Department of Planning and Zoning

TO: Development Review Board
FROM: Scott Gustin *SG*
DATE: May 17, 2011
RE: 11-0547PD; 196 North Champlain Street

Request: Combined preliminary/final plat review of planned unit development (PUD) to remove garage and construct a new detached single family home on lot with existing single family home

196 NORTH CHAMPLAIN STREET

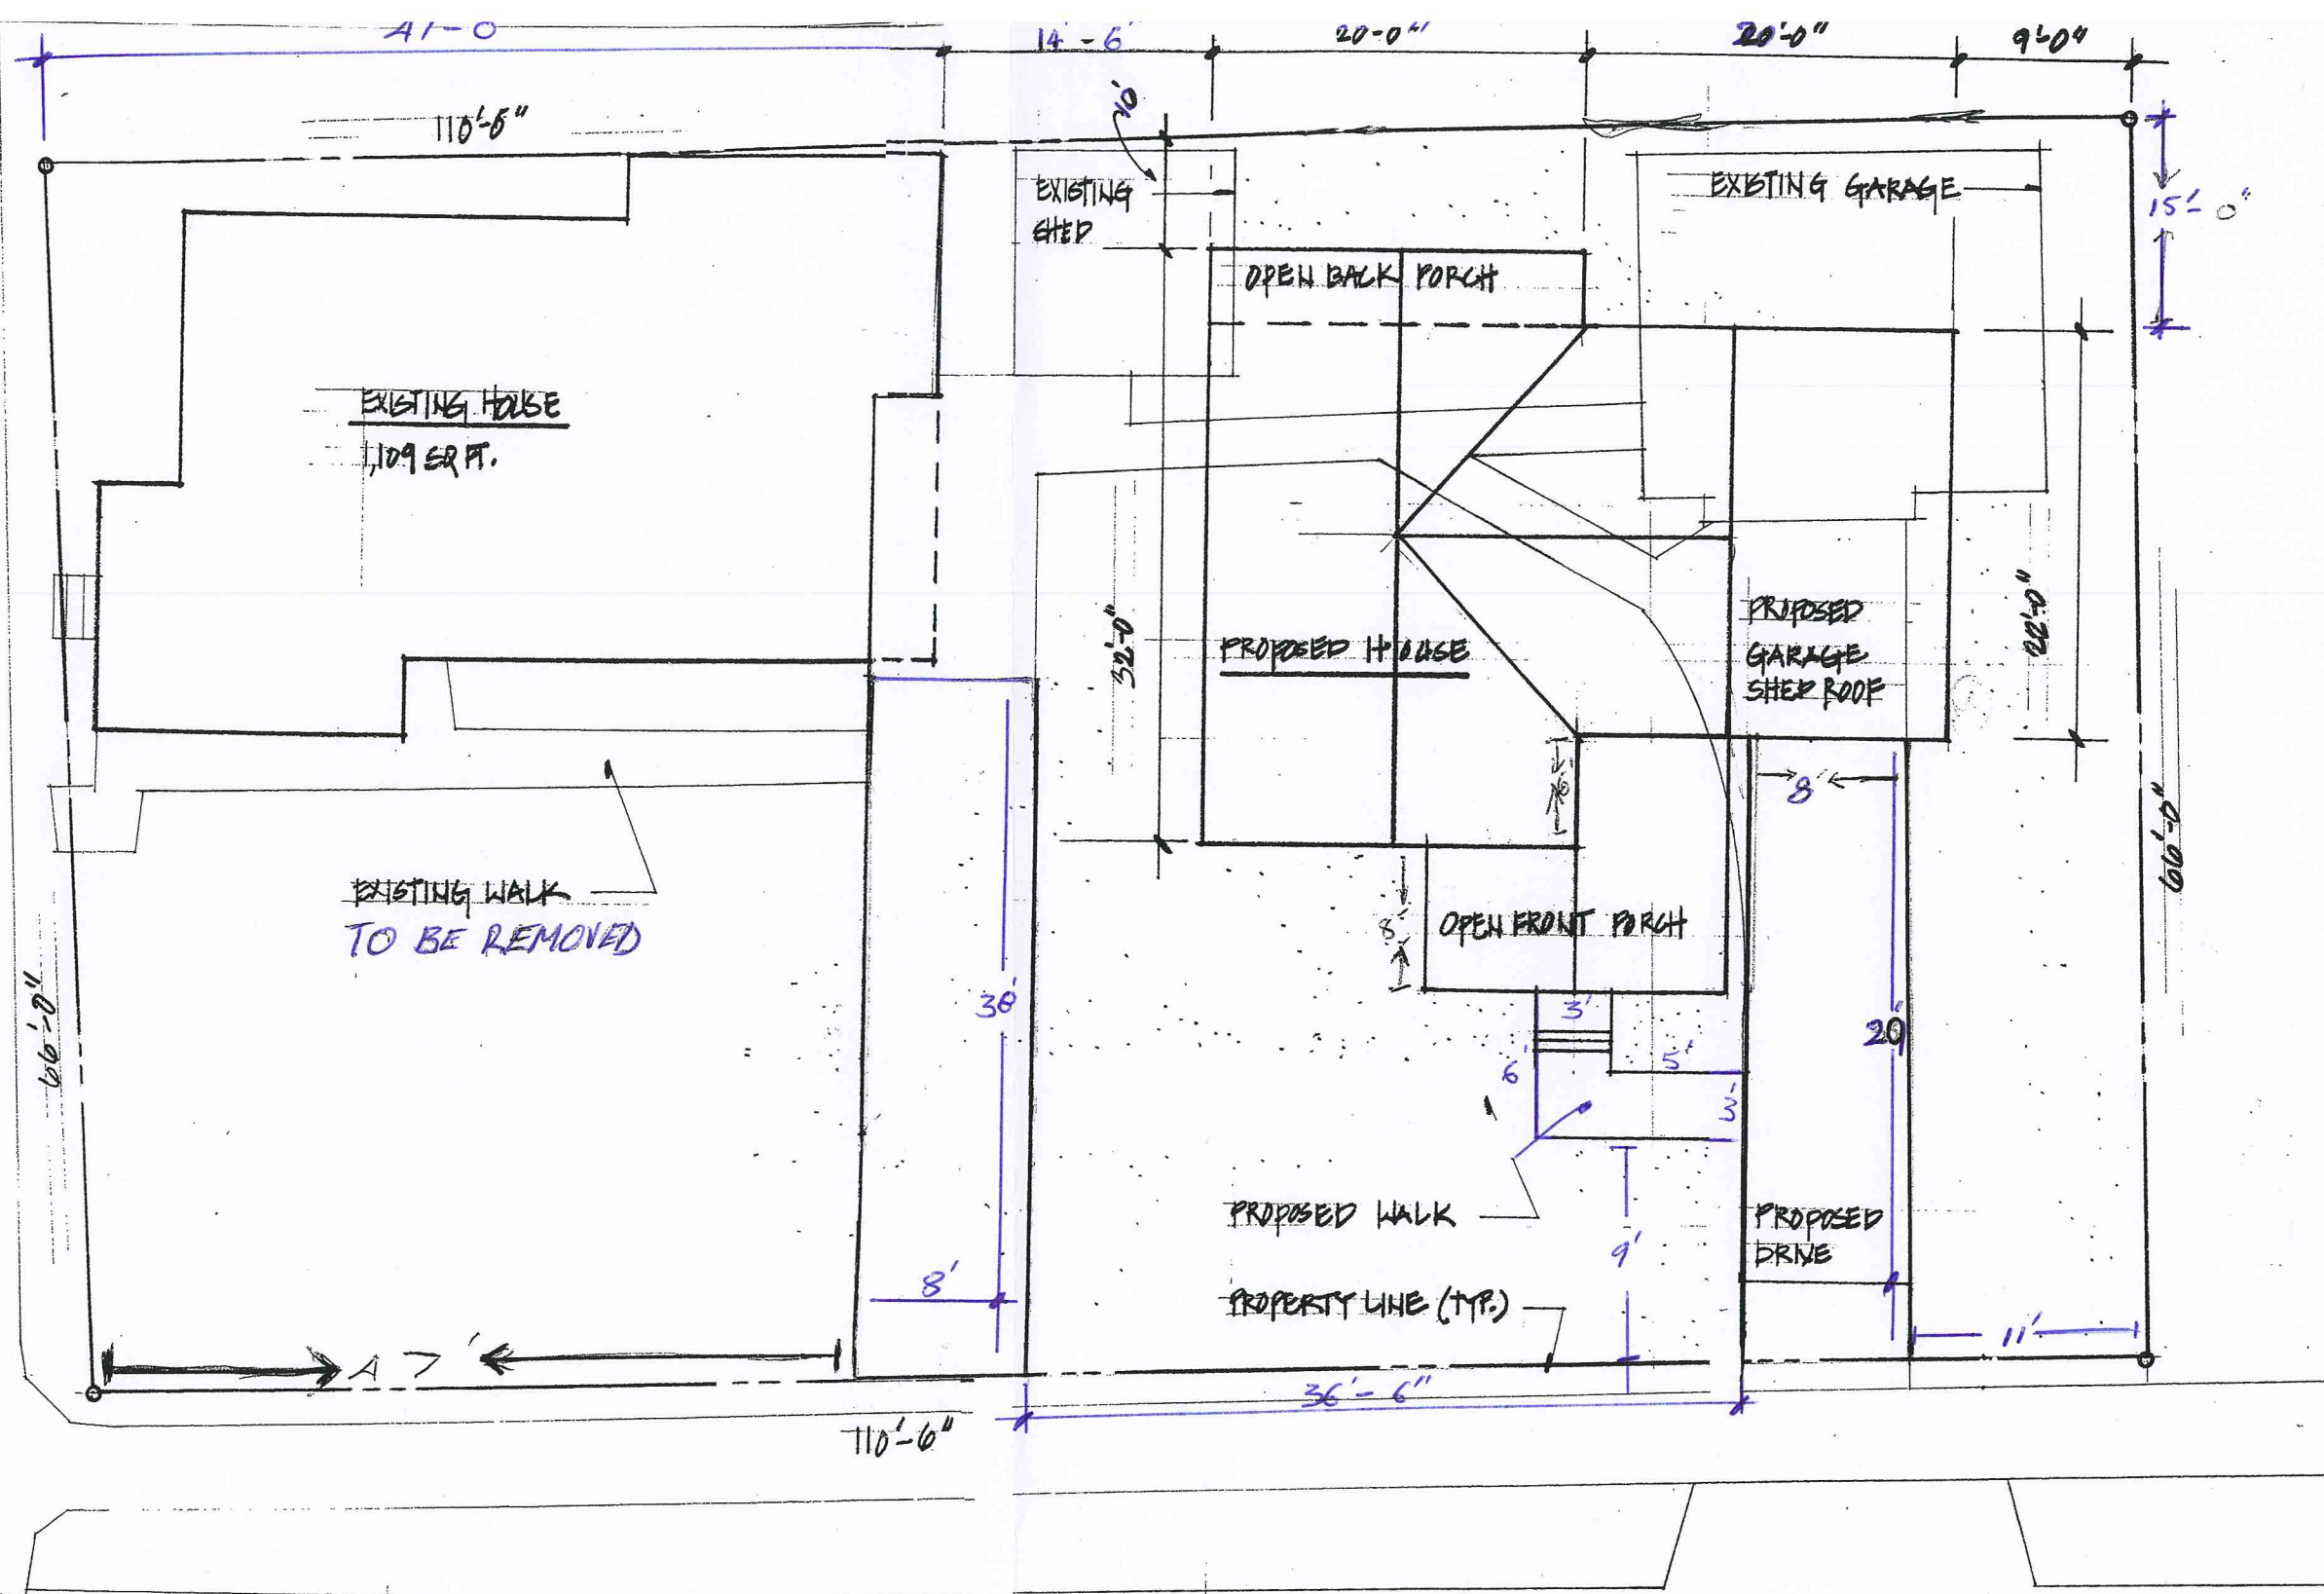
The proposed structure is oriented towards Cedar Street. Its placement is generally consistent with the existing development pattern and rhythm of structures along the street; however, as noted previously it needs to be pushed closer to Cedar Street to comply with the front yard setback. The proposed home has a clearly identifiable front entrance that is enhanced by an open front porch. The attached garage is set back from the front property line 33'. Moving the house forward may result in moving the garage as well; however, it must remain at least 25' from the front property line. The width of the entire structure along Cedar Street is 40'. The garage is 12' wide and complies with the 30% width limit (i.e. no more than 30% of the total width of the front façade). **(Affirmative finding as conditioned)**

The site plan approved by the DAB contained a walkway between the new home's front porch and the public sidewalk. The site plan as modified to contain a new driveway no longer contains this connection and must. There is adequate green space remaining to make the connection while complying with the 40% coverage limit. **(Affirmative finding as conditioned)**

Side yard setbacks are compliant as noted in Sec. 4.4.5 (b). The southern front yard setback requires that the new house be moved closer to Cedar Street as noted in Sec. 4.4.5 (b).

2. **Prior to release of the zoning permit**, revised plans shall be submitted, subject to staff review and approval. The revisions shall include:
 - a) The new house moved forward to comply with the front yard setback;

- b) A walkway connection from the new front porch to the public sidewalk;
 - c) The species and size of new plantings at the time of installation; and,

SOUTH ELEVATION

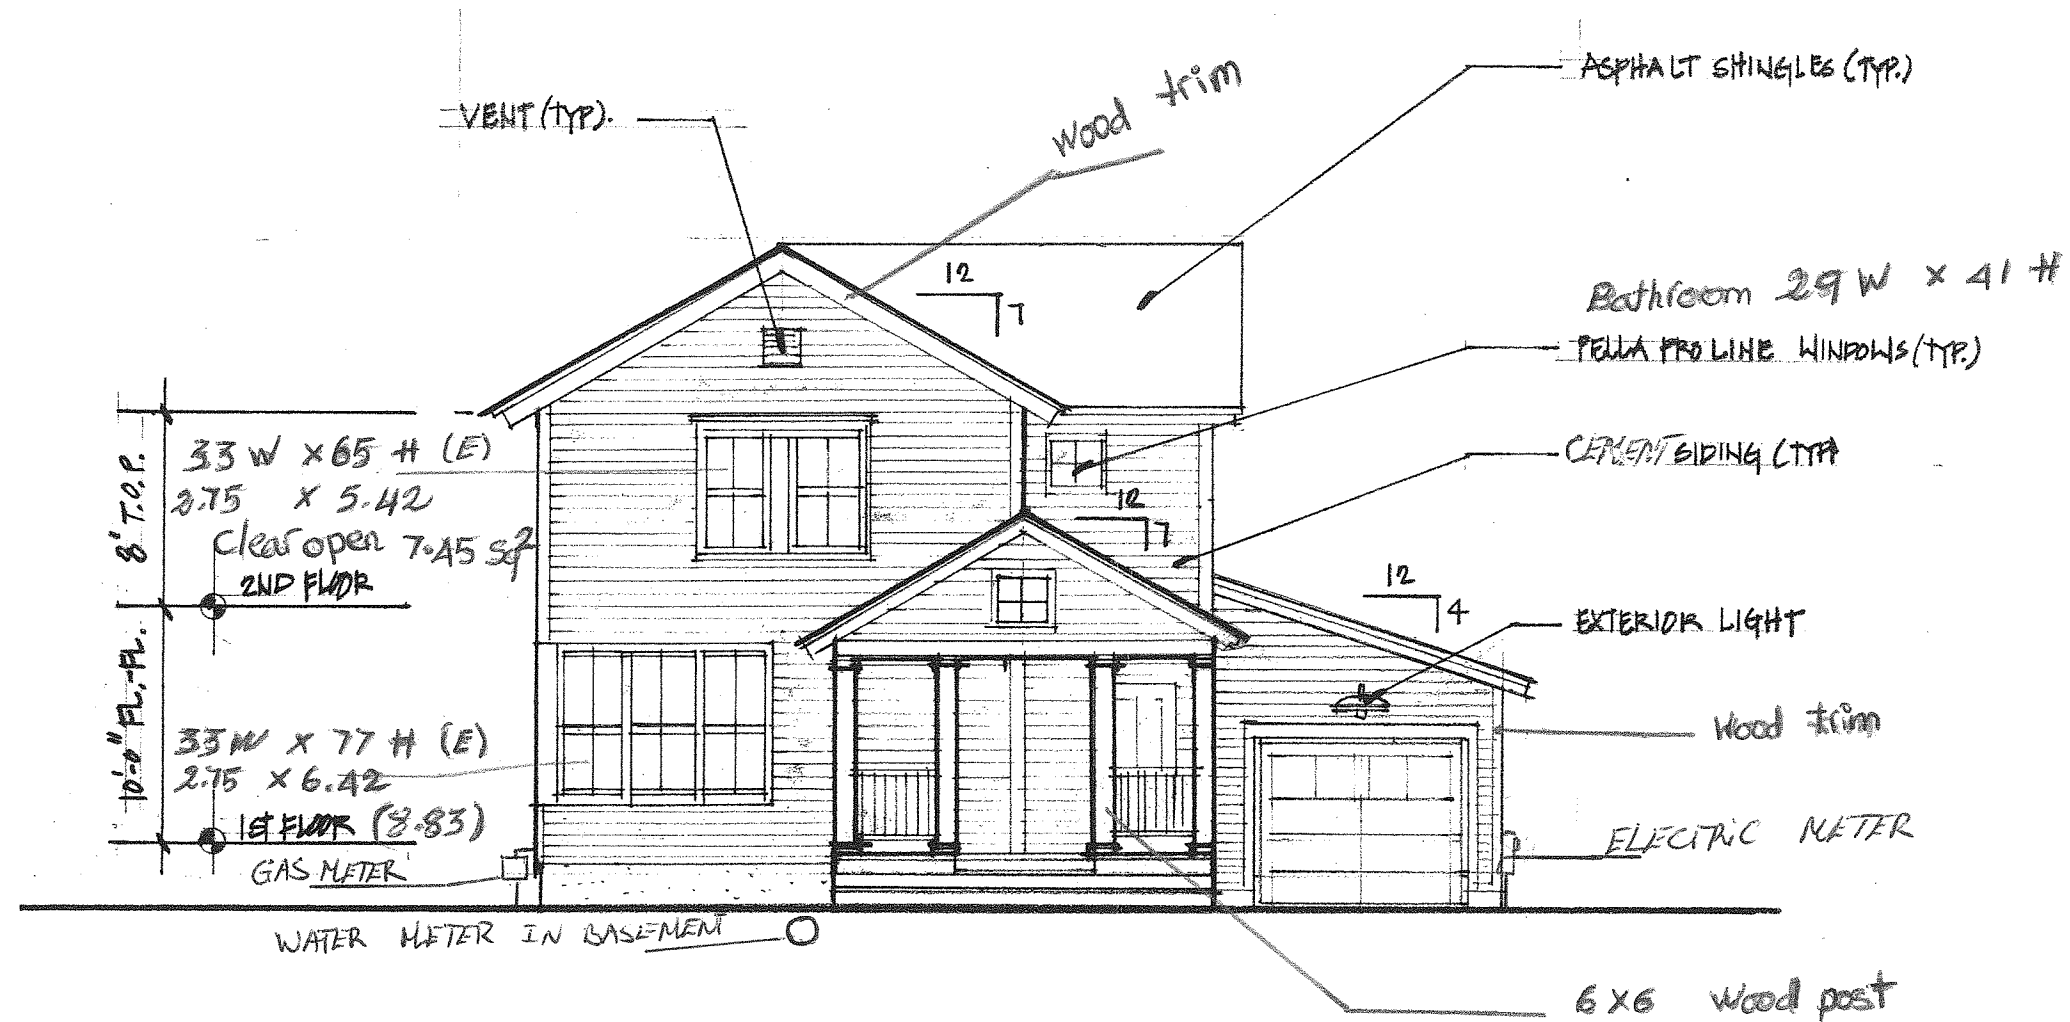
The proposed structure will be clad in cement fiberboard siding with asphalt shingle roofing. Wooden trim and porch elements are proposed. Clad wooden windows will be installed but have yet to be explicitly noted on the elevation plans and must be. The materials are of acceptable quality and durability. **(Affirmative finding as conditioned)**

- d) Notation of window materials on the elevation drawings.
3. **Prior to release of the zoning permit**, written approval of erosion control and stormwater management procedures shall be obtained from the Stormwater Administrator.
